Urgent FIELD SAFETY NOTICE

Ceiling pendant SPR 10

Device Modification

MATTER:	The change of the material for the axial segment in ceiling pendant.
ADDRESSEE:	All the users and biomedical staff dealing with the ceiling pendants
DETAILS ON AFFECTED DEVICES:	Ceiling pendants with compact, spring balanced, tilting and swivelling arms (SPR 10) Catalogue number: 093008101 Manufactured: MZ Liberec a.s. Production period: 21.4.2010 – 20.4.2015

Technical description of the corrective action:

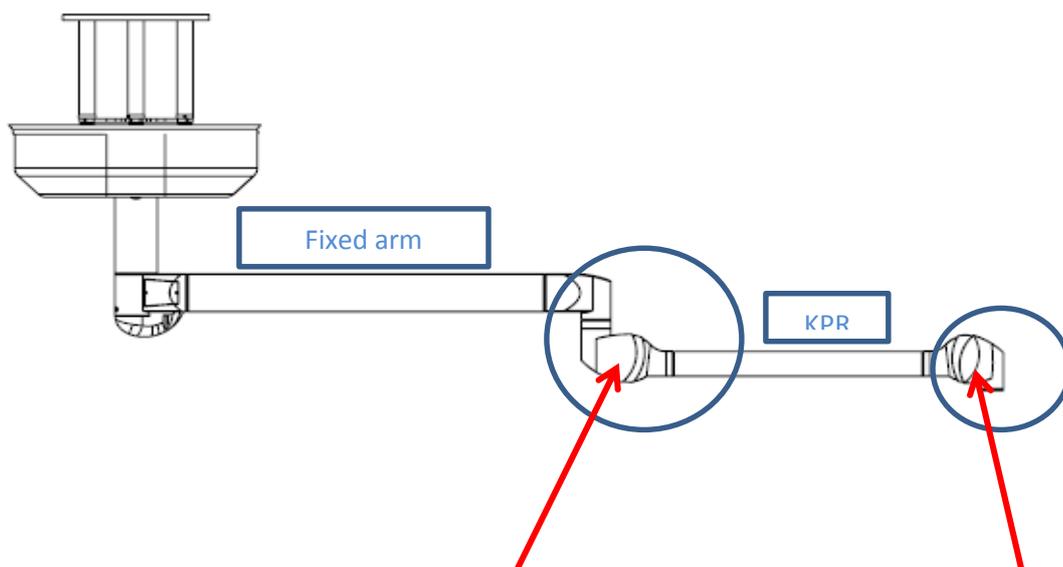
Following notification of an incident of failure of an axial segment of a ceiling pendant component, MZ Liberec is initiating a field safety corrective action. Our company will substitute all the axial segments in the field for the new ones. You should receive these new parts along with this notice. We have also increased the inspections of these components as part of the manufacturing process to prevent reoccurrence of similar incidents in the future. It is important that all users inspect the axial segment components for excessive wear. If the any part of the segment has a thickness of less than 1.7 mm, users should cease using the product immediately.

The axial segments will need to be removed and replaced with the new ones supplied to you by MZ Liberec. This process can be safely performed by the user/owner of the device.

Picture1

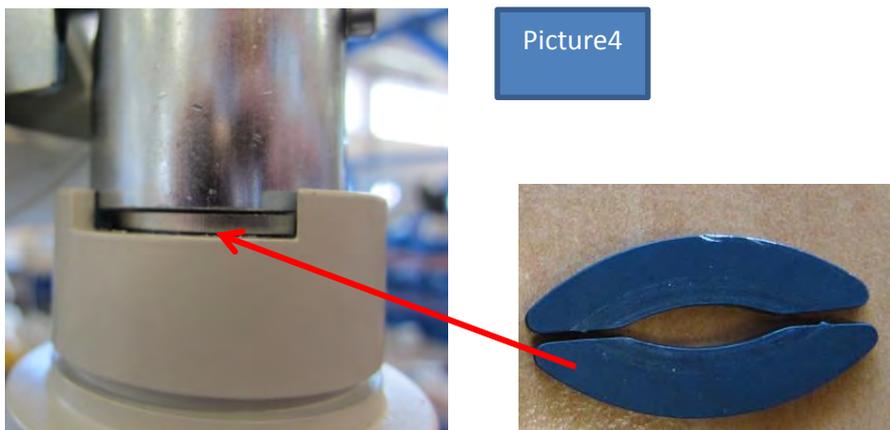
1. Take away the plastic casing between the fixed arm and the moveable arm (KPR). Then the KPR must be locked to prevent from unwanted movement (picture 1).

2. Taking away the plastic casing from KPR (picture 2) enables to take away with the screwdriver the plastic cover of the axial segments (picture 3).

Pictures for the quick and easy recognition “former” or “new” segments:

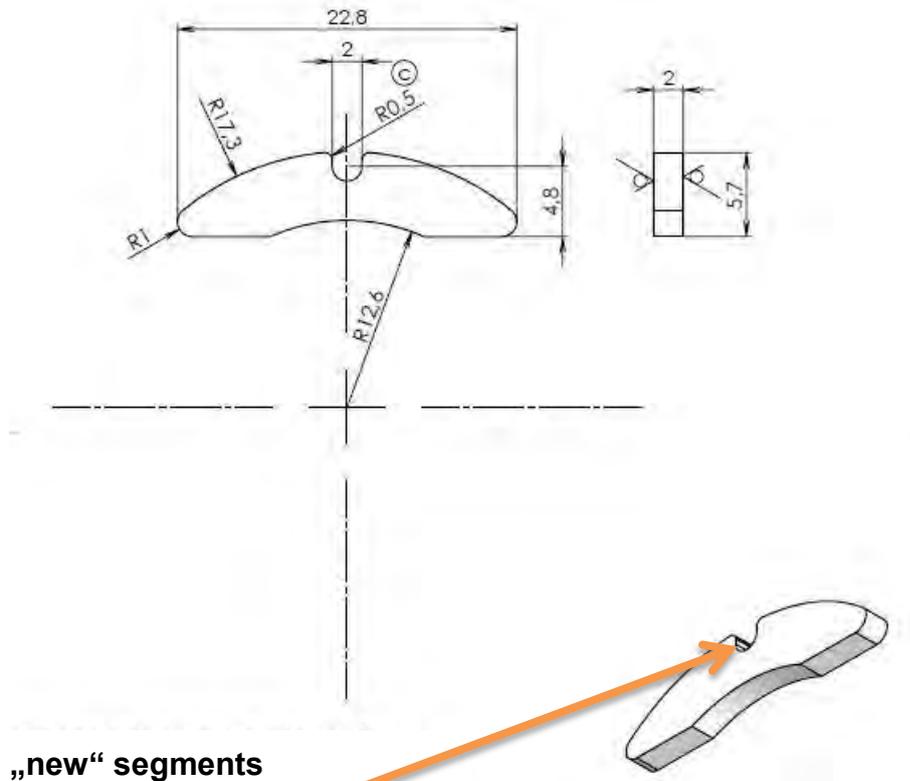
„former“ segments

Don't have the notch on the outer edge segment.

„new“ segments

Have the notch on the outer edge segment.
